World Forum for Harmonization of Vehicle Regulations**Working Party on Passive Safety****Fifty-sixth session**

Regulation No. 127 (Pedestrian safety)**Proposal for Supplement 1 to the 01 series of amendments to Regulation No. 127 (Pedestrian safety)****Submitted by the expert from the European Commission as Chair of the Task Force on Bumper Test Area within the Informal Working Group on global technical regulation No. 9 Phase 2***

"Figure 5A

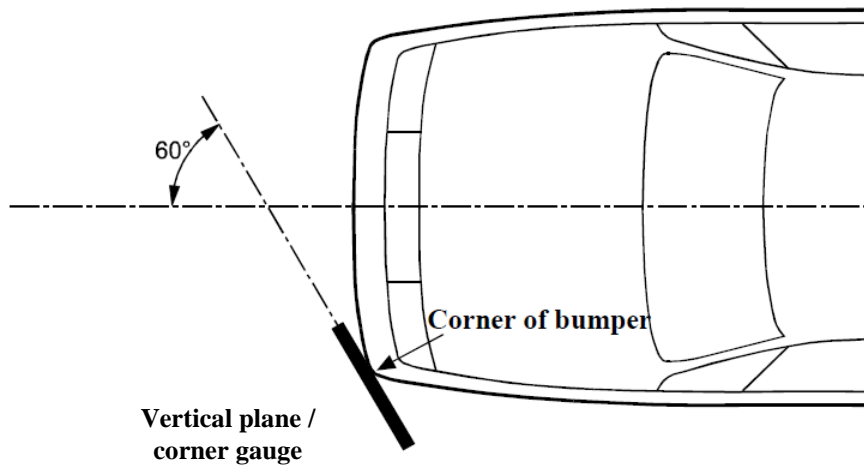
Figure 5, amend to read:

Corner of bumper example (see paragraph 2.16., note that the corner gauge is to be moved in vertical and horizontal directions to enable contact with the outer contour and front fascia of the vehicle)

"2.16. *"Corner of bumper"* means **the transversal position of the vehicle's point of contact with a vertical plane which makes an angle of 60° with the vertical longitudinal plane of the vehicle and is tangential to the outer surface of the bumper (see Figure 5).** ~~corner gauge as defined in Figure 5B.~~

For determination of the corner of bumper, the front surface of the corner gauge is moved parallel to a vertical plane with an angle of 60° to the vertical longitudinal centre plane of the vehicle (see Figures 5A and 5C) at any height of the centre point of the corner gauge in the following area:

Figure 5B
Corner gauge

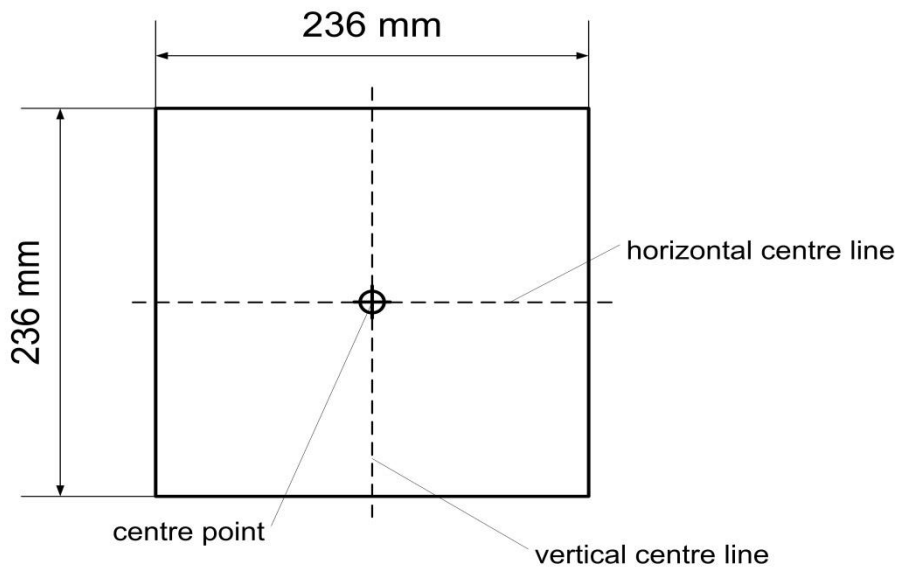
The front surface of the corner gauge is flat.

The centre point is the intersection of the vertical and horizontal centre lines on the front surface.

Figure 5C
Determination of the corner of the bumper with the corner gauge (shown in random location)

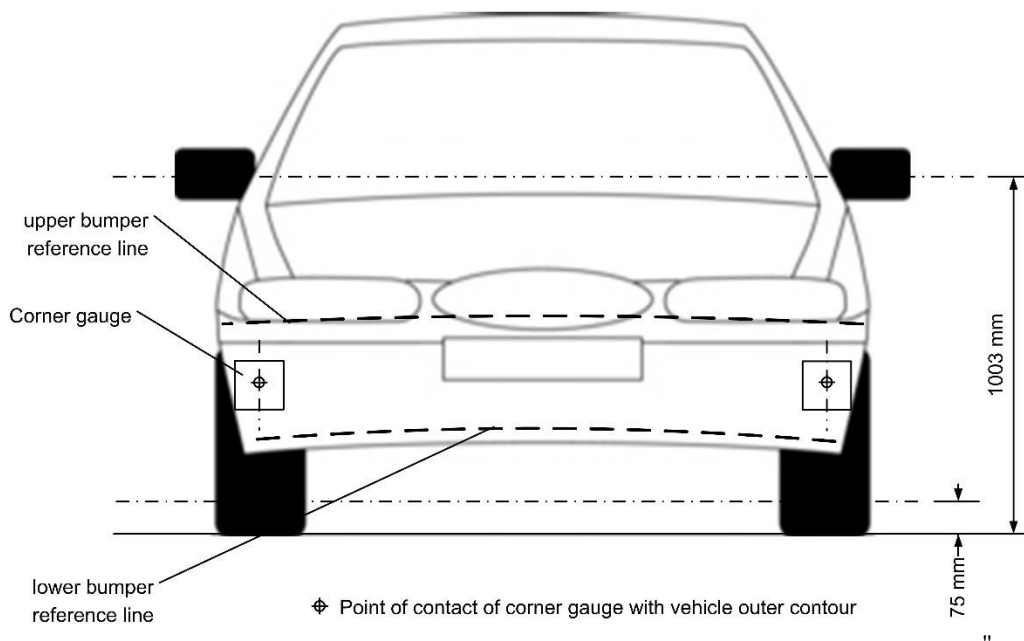
For determination of the corner of bumper, the gauge is moved to contact the outer contour/front fascia of the vehicle touching at the vertical centre line of the gauge. The horizontal centre line of the gauge is kept parallel to the ground plane.

The corners of bumper on both sides are subsequently defined as the outermost points of contact of the gauge with the outer contour/front fascia of the vehicle as determined in accordance with this procedure. Any points of contact on the top and the bottom edges of the gauge are not taken into account. The rear and side view mirrors and the tyres shall not be considered."
